**PCN#20250618010.1**  
**BQ2969/T Die Revision Change, Pin 1 Orientation Change, and Datasheet Update**  
**Change Notification / Sample Request**

<b>PCN Number:</b>	20250618010.1	<b>PCN Date:</b>	June 18, 2025
<b>Title:</b>	BQ2969/T Die Revision Change, Pin 1 Orientation Change, and Datasheet Update		
<b>Customer Contact:</b>	Change Management team	<b>Dept:</b>	Quality Services
<b>Proposed 1<sup>st</sup> Ship Date:</b>	September 16, 2025	<b>Sample requests accepted until:</b>	August 17, 2025*

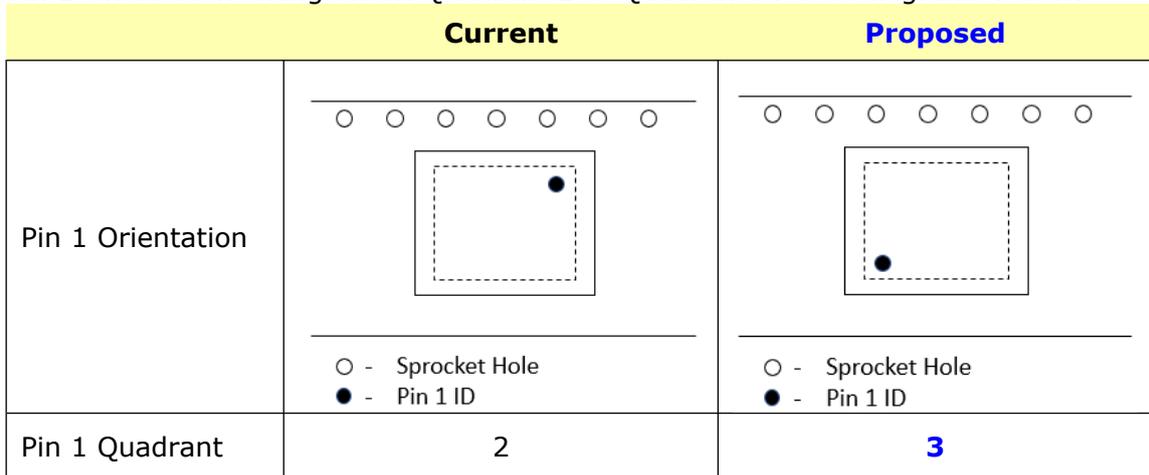
The Pin 1 Orientation change from Quadrant 2 to Quadrant 3. See diagrams below:
